TO: Mercedes-Benz Dealer Principals, General Managers, Sales Managers, Service Managers, Parts Managers	FROM: Anthony Washington, Department Manager, Regulations and Certifications
Re: Service Campaign Notification Model 907 (Sprinter) Model Year 2021 Replace Vehicle Emission Control Information Label	DATE: July, 2022

Campaign No. 2022070008 July, 2022

SUBJECT: **Model 907 Model Year 2021
Replace Vehicle Emissions
Control Information label**

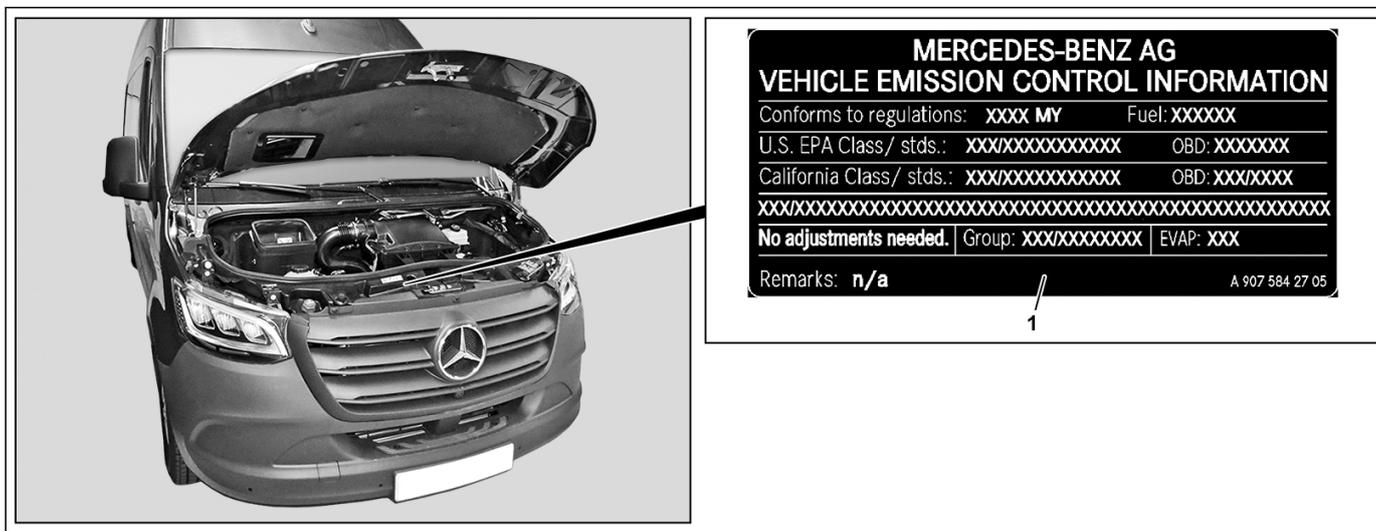
MBAG, the manufacturer of Mercedes-Benz Sprinter vehicles, determined that in certain vehicles, the VECI label does not correspond to current production configuration.

An authorized Mercedes-Benz Sprinter dealer will replace the Vehicle Emission Certification Information (VECI) label on the affected units.
